Development Application D-4-2020

Reconfiguring a Lot (one lot into two lots)

379 Limestone Creek Road, Adelaide Park

Gretta Cowie – Planning Officer

Biodiversity Overlay – Habitat and Vegetation

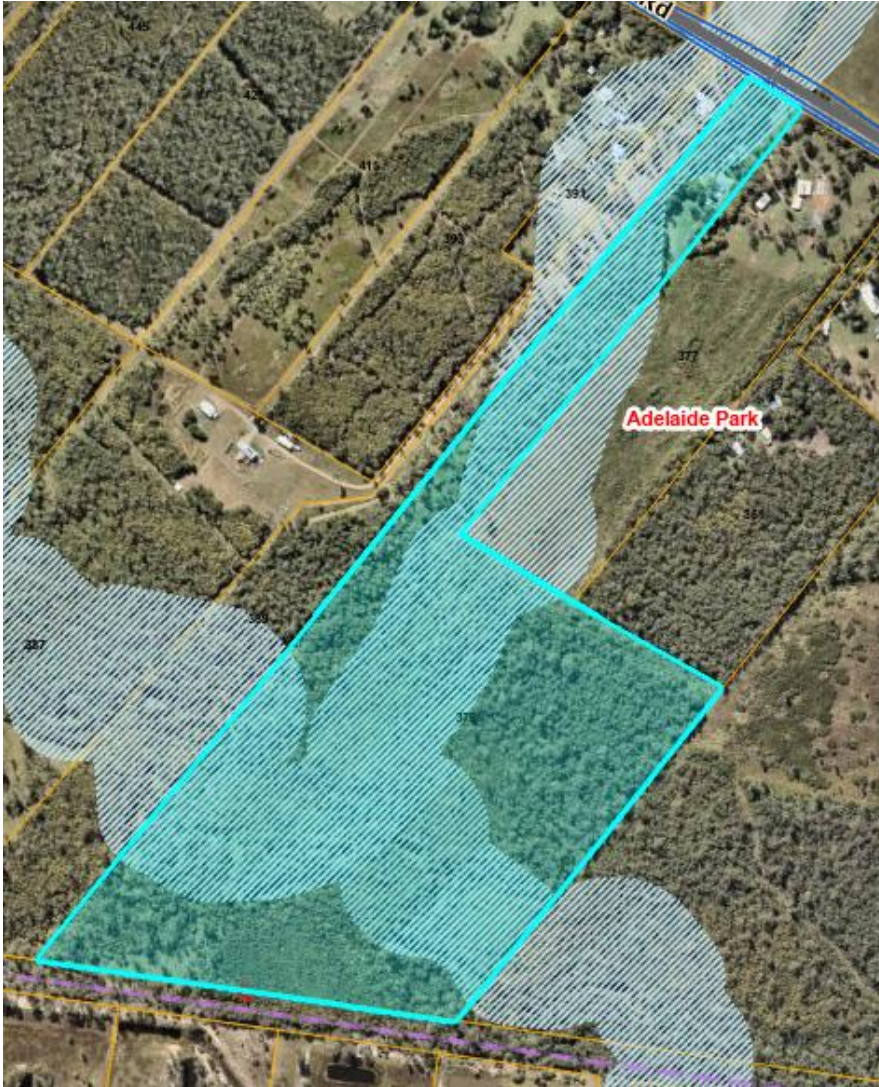
- Approximately **1.69** hectares of vegetation is required to be cleared. This does not include fire management trails or lines.
- Adverse impacts on the ecological function with the introduction of foreign matter (associated with the construction and maintenance of a residential uses)

North
to
South
link

Biodiversity Overlay – Stream order

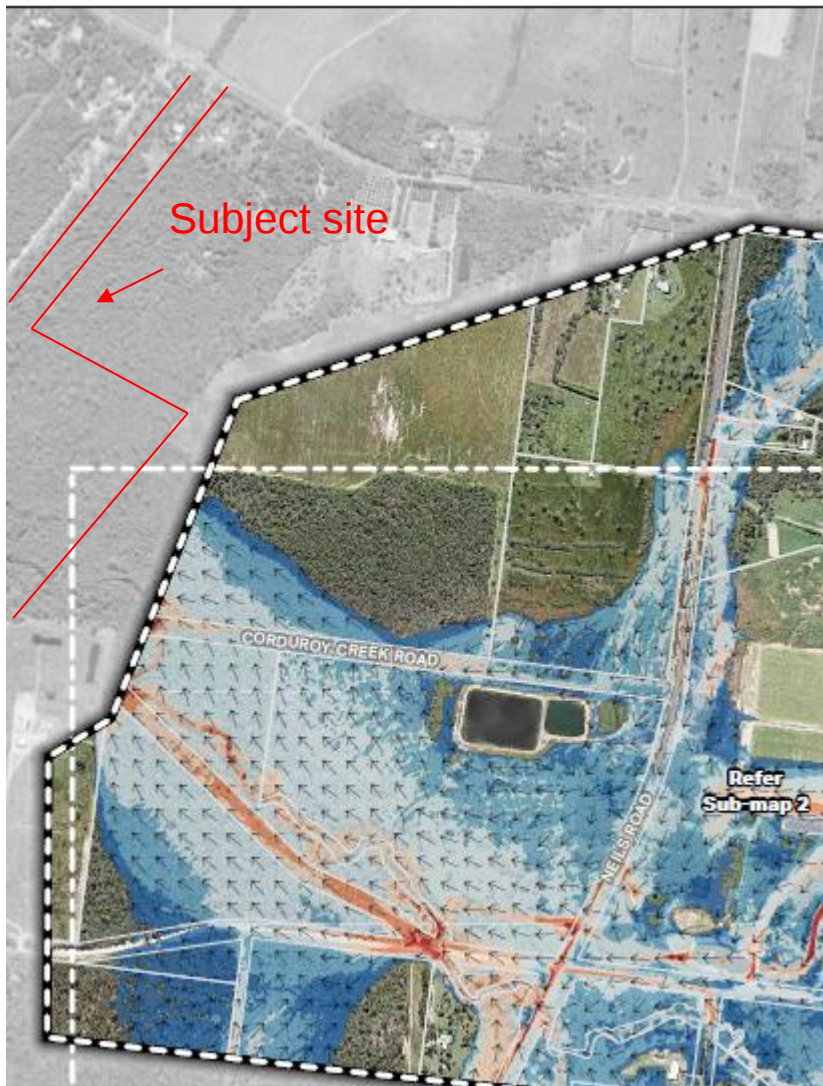
- Multiple waterways intersect in the southern portion of proposed Lot 2.
